Model: Model PN-C1	Date: 4-Dec-06	No.: RB299001
--------------------	----------------	---------------

Subject: Firmware Release Note: System FW		Prepared by: T. Shintani	
From: 1st Tech. Support Sec. Service Support Dept.			
Classification:	<input type="checkbox"/> Troubleshooting	<input type="checkbox"/> Part information	<input type="checkbox"/> Action required
	<input type="checkbox"/> Mechanical	<input type="checkbox"/> Electrical	<input type="checkbox"/> Service manual revision
	<input type="checkbox"/> Paper path	<input type="checkbox"/> Transmit/receive	<input type="checkbox"/> Retrofit information
	<input type="checkbox"/> Other ()

Model: Model PN-C1		Date: 7-Jul-07	No.: RB299003
Subject : ADF No-feed problem		Prepared by: T. Shintani	
From: 1st Tech. Support Sec. Service Support Dept.			
Classification:	<input checked="" type="checkbox"/> Troubleshooting <input type="checkbox"/> Part information <input type="checkbox"/> Action required <input type="checkbox"/> Mechanical <input type="checkbox"/> Electrical <input type="checkbox"/> Service manual revision <input type="checkbox"/> Paper path <input type="checkbox"/> Transmit/receive <input type="checkbox"/> Retrofit informa

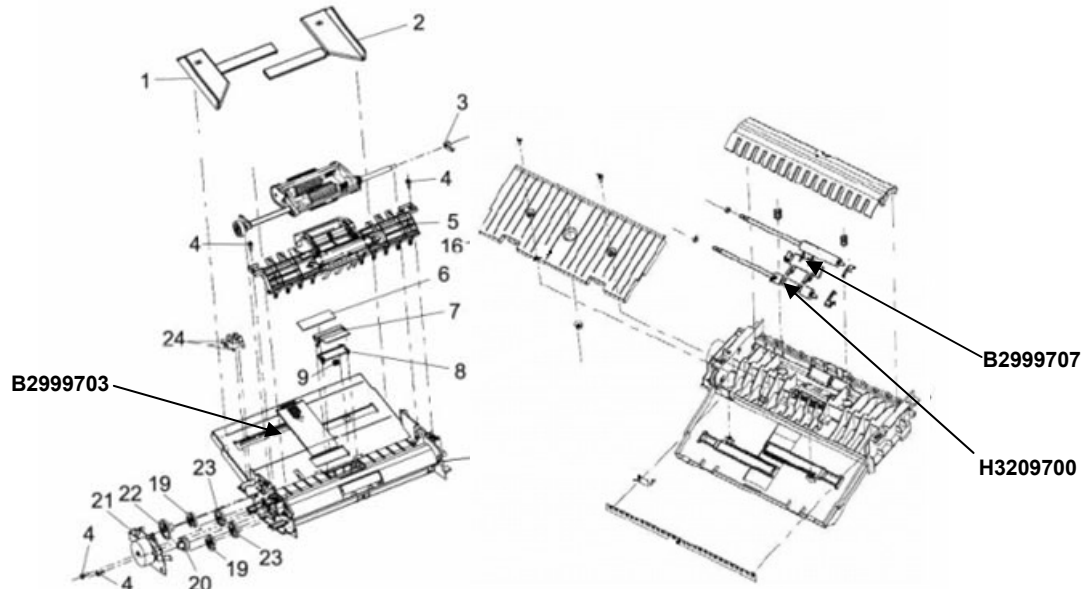
The document cannot be fed when it is loaded in the ADF.

The paper catches on the ribs of the paper input guide.

The shapes of the parts listed below were changed.

If the symptom is reported on a machine produced before the cut-in S/N, replace the paper input guide, paper feed roller foam, and paper deflect guide with the following new parts **together as a set**:

B2999703: PAPER INPUT GUIDE

H3209700: PAPER FEED ROLLER FOAM_COUNTERMEASURE

B2999707: PAPER DEFLECT GUIDE

8.ADF Unit 2 (B299)

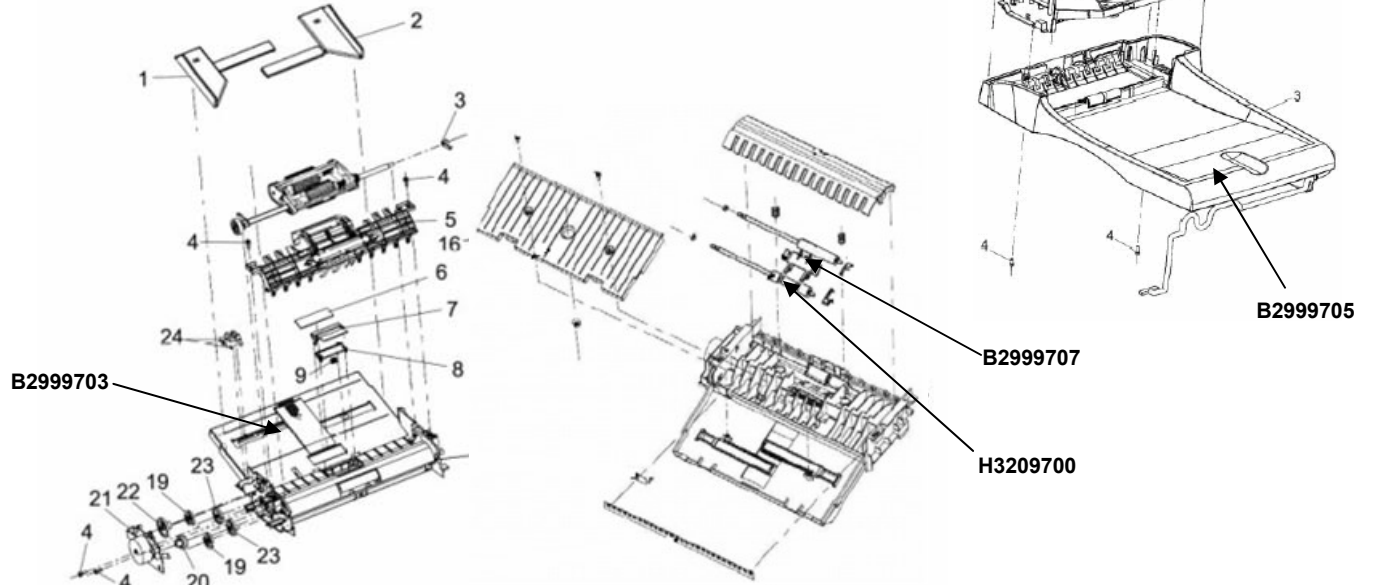
When the document is scanned by the ADF, parts of the image are slightly elongated along the sub-scan direction (at 13mm, 50mm, 230mm from the leading edge).

The document bumps the paper guide and feed rollers during feeding.

The shapes of the parts listed below were changed.

If the symptom is reported on a machine produced before the cut-in S/N, replace the ADF exit tray, paper input guide, foam, and paper deflect guide with the following new parts **together as a set**:

B2999705: ADF EXIT TRAY

B2999703: PAPER INPUT GUIDE

H3209700: PAPER FEED ROLLER FOAM_COUNTERMEASURE

B2999707: PAPER DEFLECT GUIDE

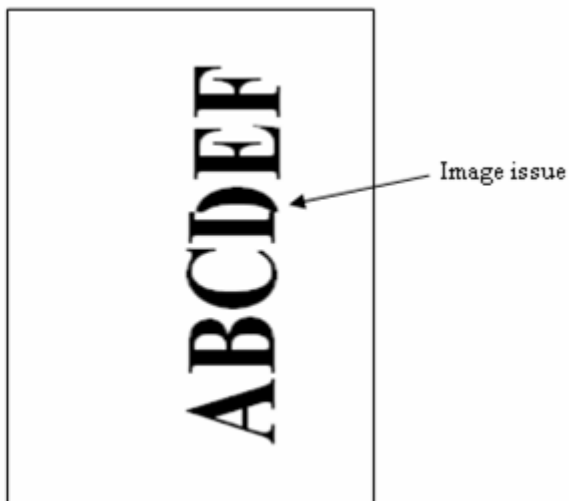
1. An incoming fax image is blank (but contains the fax headers)
2. Some parts of incoming fax Image are shifted or blank.

The fax line is unstable or electrical noise distorts the fax line signal.

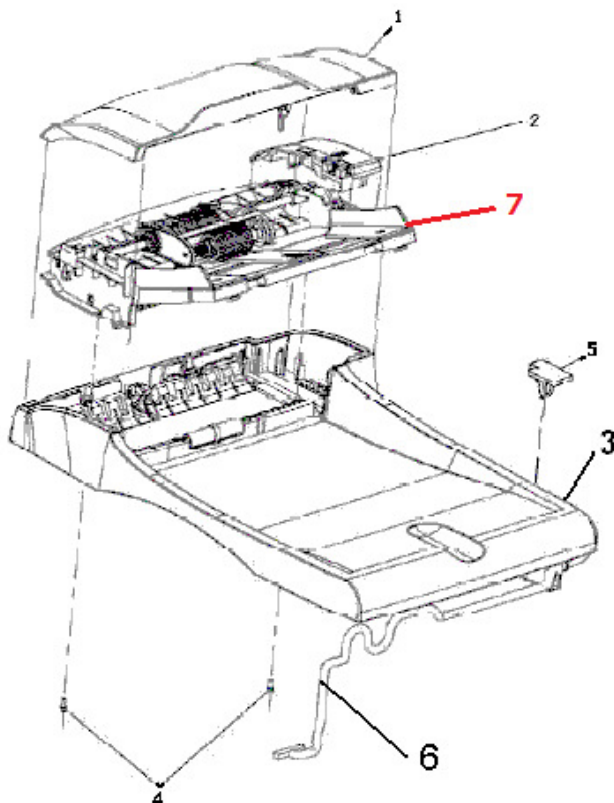
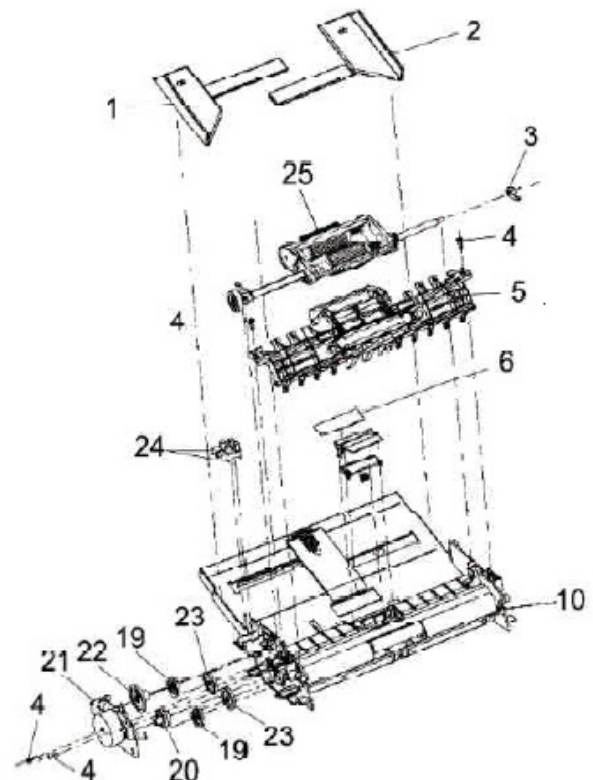
Change/Reason: Vendor change

Due to a vender change, Paper Roller Ass'y (Index 25) cannot be supplied any more. Please replace the assembly of M0489502 (New Index 7) instead.
